## Product Change Notice (PCN)

**Subject:** RA2E2 group I3C function revision

PCN#[MCP-AC-22-0010]

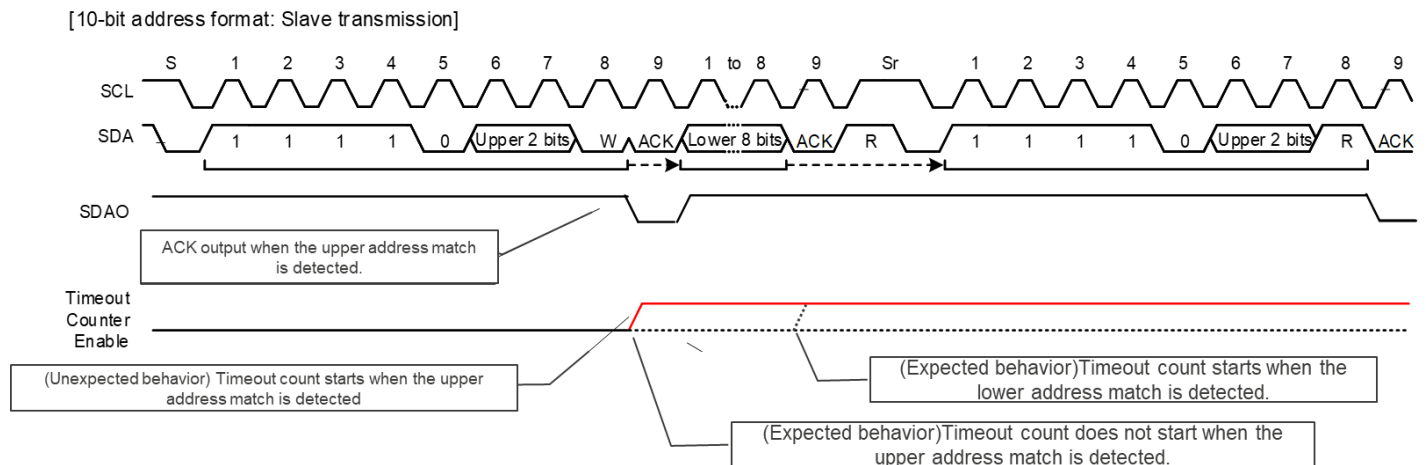
In MCU Ver.1, when the output timing of the first data of the frame and the transmission data write timing are conflicted, the transmission of the first data to be transmitted (b7) will start with a deviation of 1 bit.

MCU Ver.1 requires the software workaround when writing transmission data, but MCU Ver.2 does not require the software workaround.

Note: [MCU Ver.1 has the following restrictions and workarounds. These restrictions and workarounds are not required for MCU Ver.2.](#)

The following processing is required when checking NTST.TDBEF0 = 1 in Steps [3] and [4] of the I<sup>2</sup>C master transmission flowchart as shown in Figure 25.104.

After confirming NTST.TDBEF0 = 1, confirm that PRSTDBG.SCILV = 0 (check the status of SCL) before writing the transmission data.

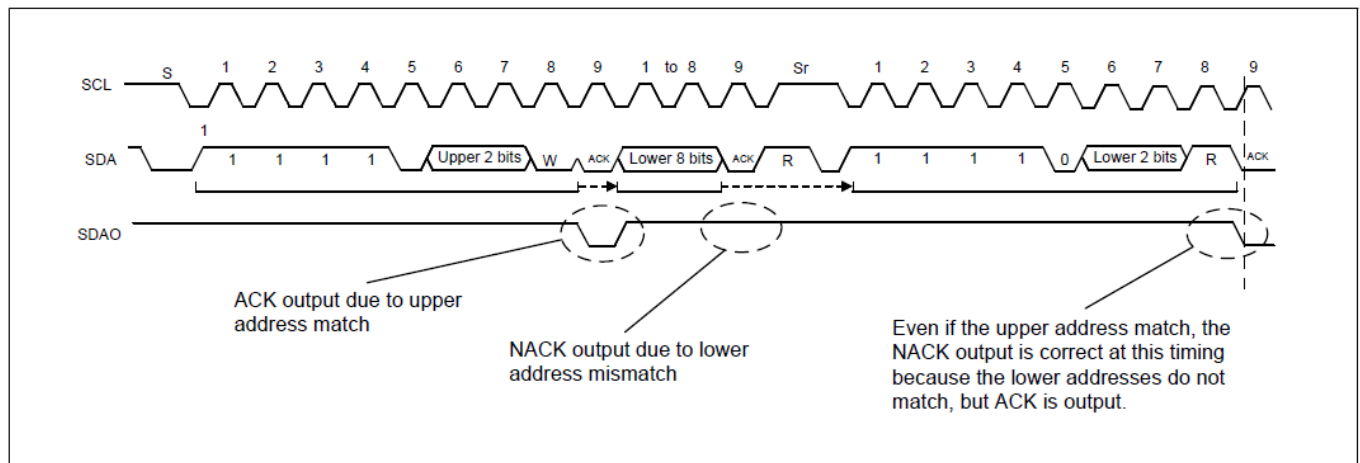
In MCU Ver.1, the timeout count starts when 10-bit address communication and the upper address match is detected.

MCU Ver.2 is revised the circuit so that the timeout count does not start until the lower address match is detected after the upper address match is detected.

Note: **MCU Ver.1 has the following restriction. The restriction is not required for MCU Ver.2.**

When working with I<sup>2</sup>C Slave, during 10-bit address communication, the timeout count starts when the upper address match is detected.

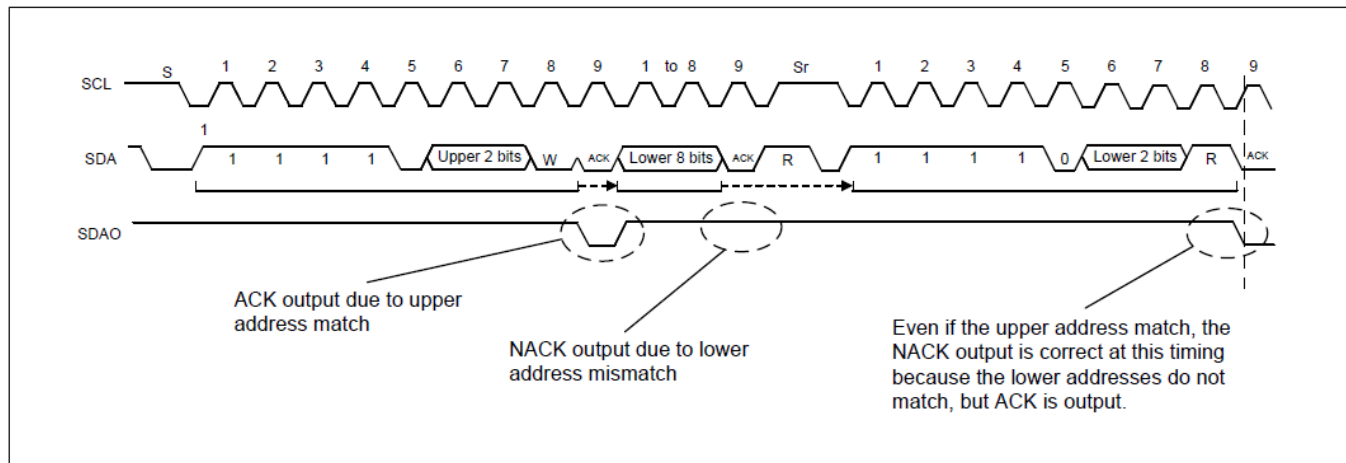
MCU Ver.1 has the following restrictions and workarounds when using 10-bit address communication. The restrictions and workarounds are not required for MCU Ver.2

MCU Ver.1 has the following restrictions and workarounds. The restrictions and workarounds are not required for MCU Ver. 2.

- Work around : Set the upper 2 bits of the 10-bit address assigned to this module to a value different from other Slave. If the address is exhausted and cannot be set to a different value, use restriction (1).
- Restriction (1) : 10-bit address not available.
- Restriction (2) : After the ACK response in the red circle in the above figure, none of the slaves respond to data, so the SDA keeps the high level and the I<sup>2</sup>C Master receives the 0xFF data. In the case of a system that can handle 0xFF as abnormal data, 0xFF is read and discarded on the I<sup>2</sup>C Master side. If 0xFF is valid data, use restriction (1).

#### # 4 : I3C slave; Arbitration operation when Dynamic Address is assigned by the ENTDAAC command

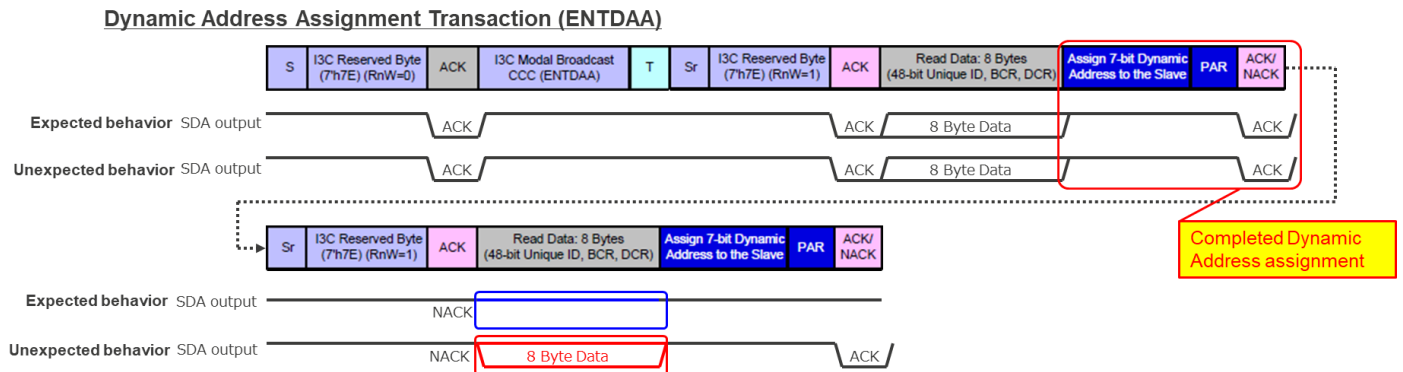
In MCU Ver.1, if a dynamic address is assigned by the ENTDAAC command in I3C slave mode, I3C will participate in dynamic address arbitration in response to the ACK response of other slaves even after the dynamic address assignment.

MCU Ver.1 requires the restrictions and workarounds when assigning dynamic address, but the restrictions and workarounds are not required for MCU Ver.2.

**MCU Ver.1 has the following restriction and workaround. This restriction and workaround are not required for MCU Ver.2.**

1. Set the SDCTPIDH and SDCTPIDL registers (6 Bytes) of the I3C (I3C Slave) to a value (All 1 etc.) that has a lower priority than other Slave Devices by Dynamic Address Arbitration.
2. After setting the Static Address in the I3C (I3C Slave), assign the Dynamic Address using the SETDASA / SETAASA command.
3. Assign a Dynamic Address to an I3C Slave Device other than the I3C (I3C Slave) using the ENTDAAC command.

**Figure 25.96-2 Example of error recovery operation flowchart for I3C Master**

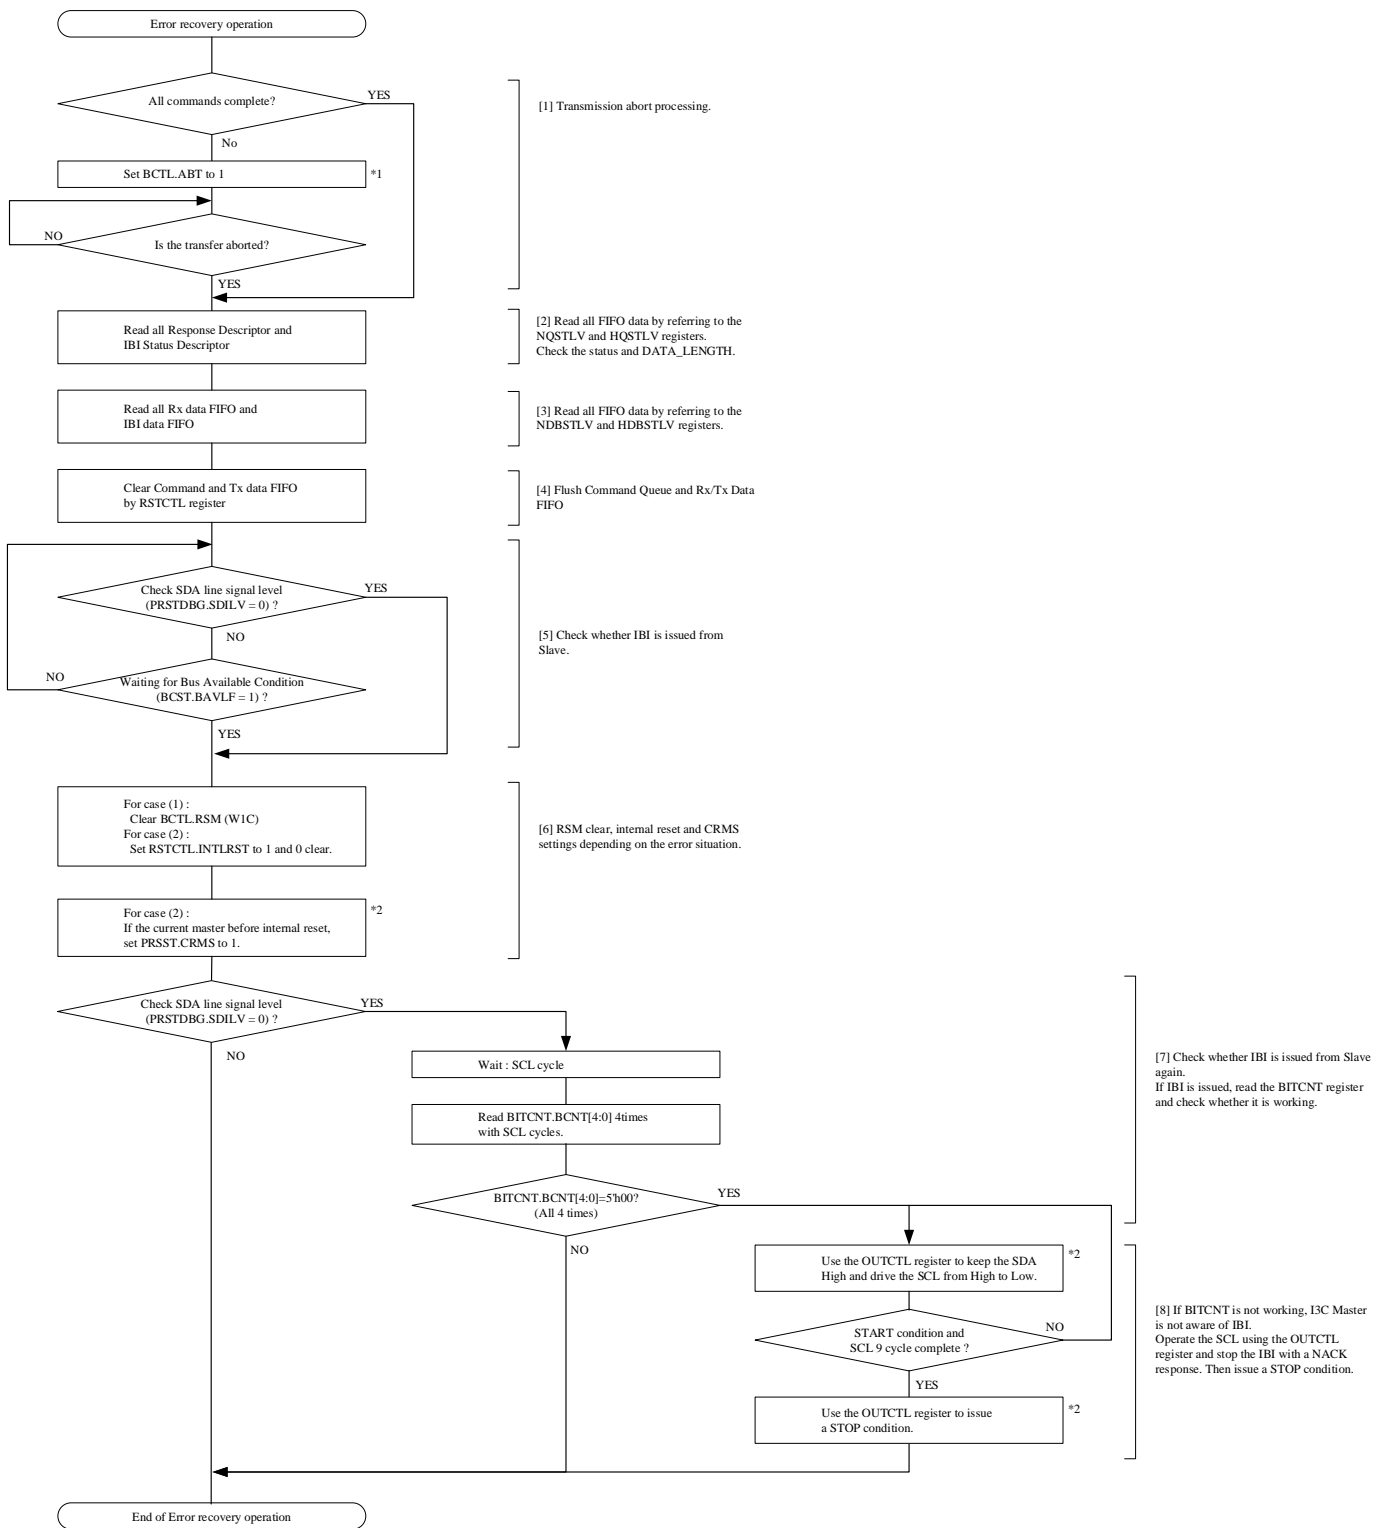
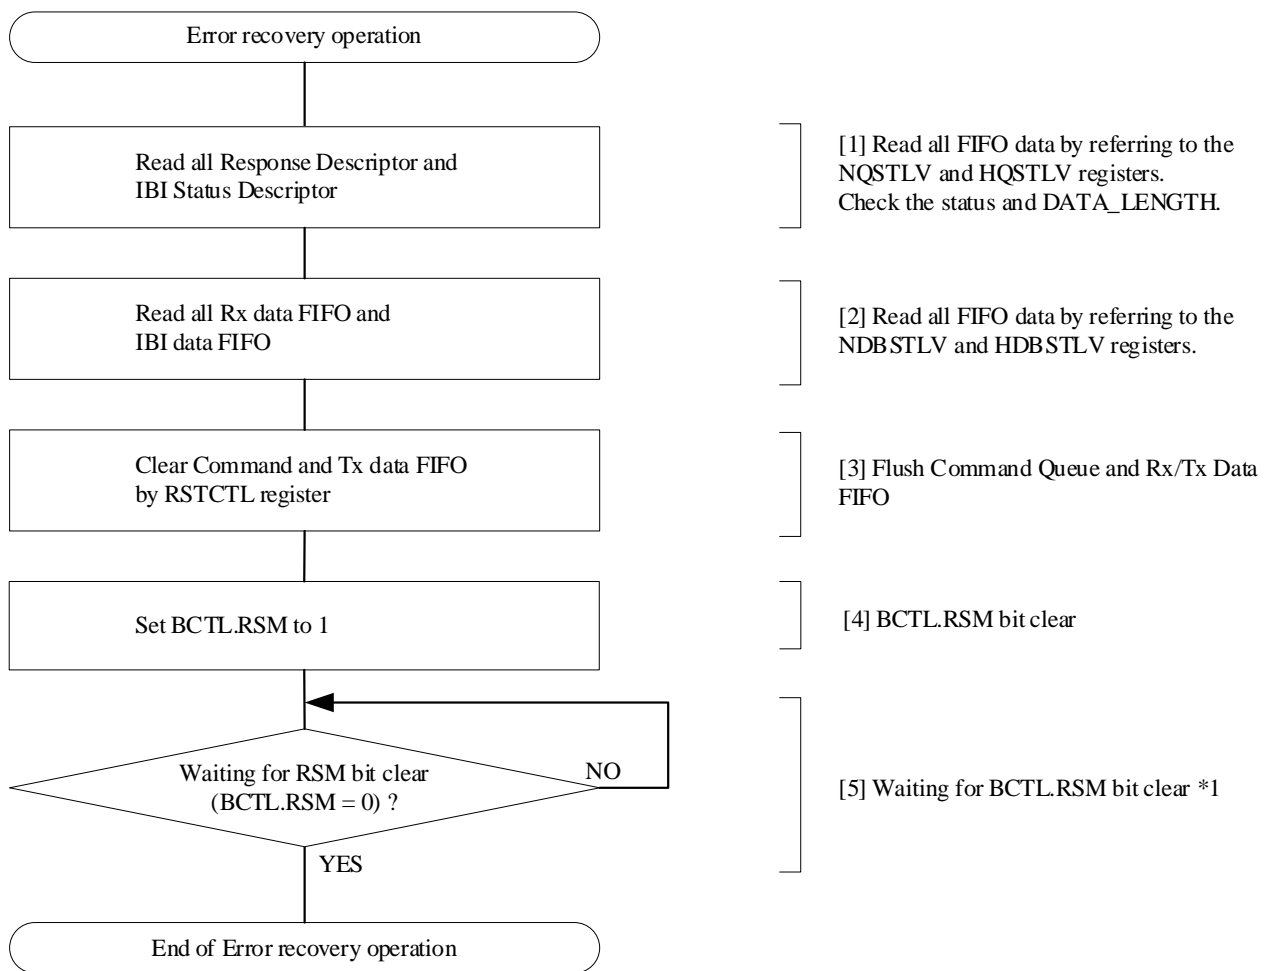
In order to improve the complexity of the error recovery flow, MCU Ver.2 is revised the circuit so that I3C will be suspended (BCTL.RSM becomes 1) when an error occurs. After I3C is suspended, the application must write the value 1 to the BCTL.RSM bit to resume I3C operation and recover from suspended state.

In MCU Ver.2, the error recovery flow shown in Figures 25.96 and Figures 25.97 are simplified by the above improvements.

**Note:** For MCU Ver.2, apply the following error recovery flow.

If an error occurs, I3C will be suspended. (BCTL.RSM becomes 1.) After I3C is suspended, the application must write the value 1 to the BCTL.RSM bit to resume I3C operation and recover from the suspended state.

Figure 25.96-2 and Figure 25.97-2 show the error recovery flow of MCU Ver.2.
